LMK5B12204 Schematic Review

The recommended pin terminations for the LMK5B12204 schematic are as follows.

Figure 10-3. Recommendation for Power Up From Split-Supply Rails

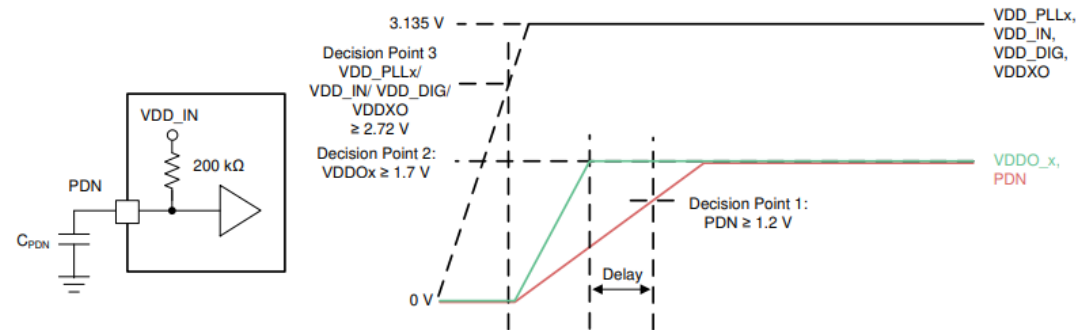
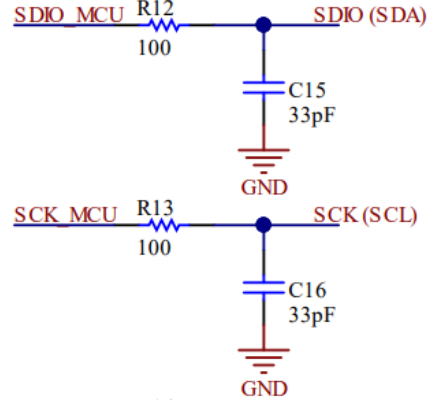
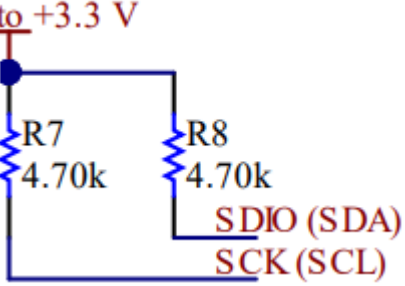
The PDN pin has an internal pull up, so external pull up is not required. Remove the 10 kohm to VCC.

Since you are powering up the VDD and VDDO with separate supplies, please place a 0.01 uF to GND on the PDN pin. This is the only termination required.
